**CERTIFICATE OF APPROPRIATENESS**

**Property:** 707 Henderson St, Lot 6, Tract 5, Block 407, Baker W R NSBB Subdivision. The property includes a historic 1,200 square foot, one-story wood frame single-family residence situated on a 5,400 square foot (54' x 100') corner lot.

**Proposal:** Alteration – Windows

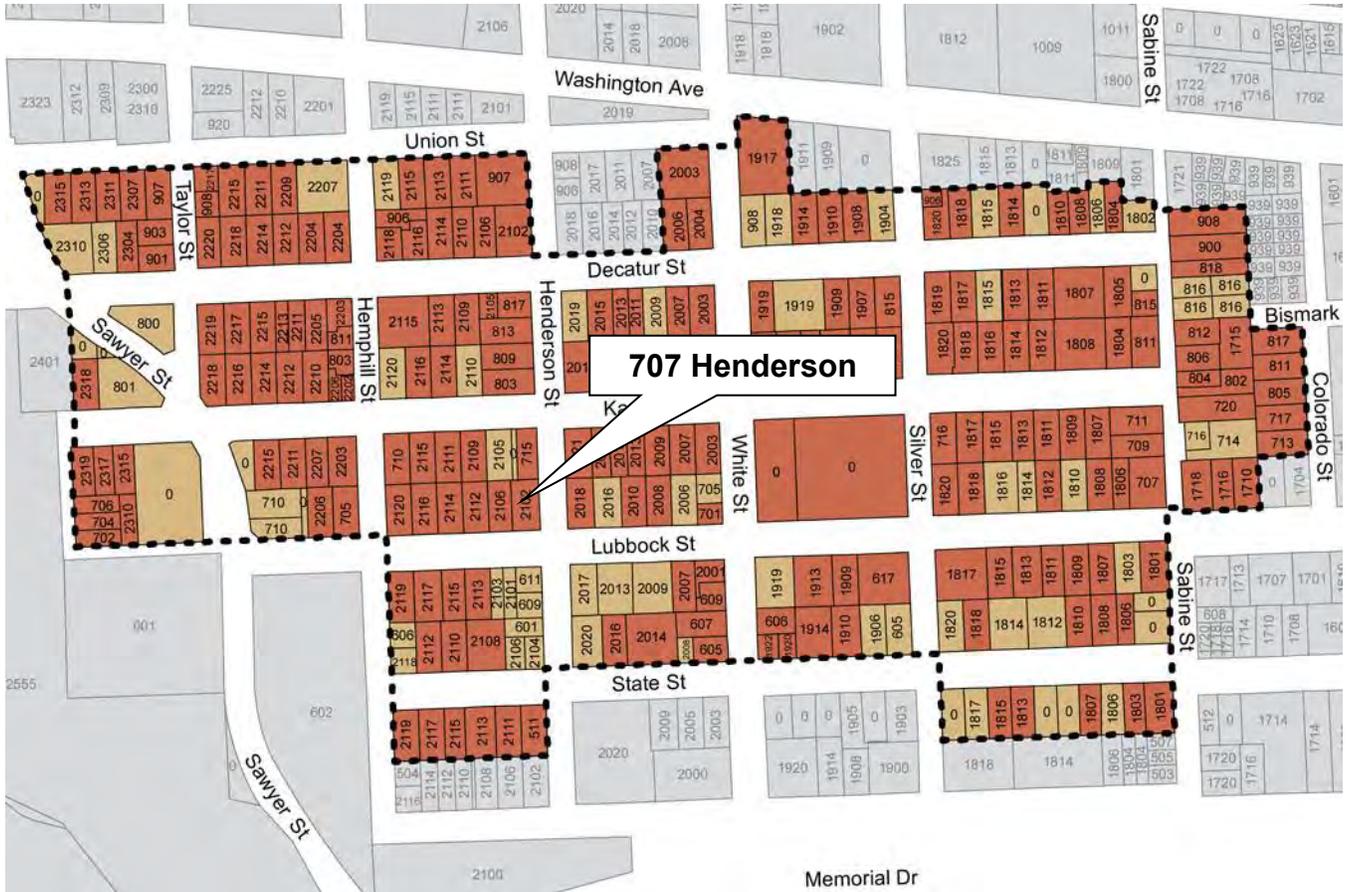
*The Old Sixth Ward Design Guidelines establish windows as character defining features of historic structures. Windows should be retained unless they are damaged beyond repair.*

*Staff recommends that the applicant remove the vinyl windows, repair the original windows (which have been salvaged by and will be returned by a neighbor), and reinstall the original windows.*
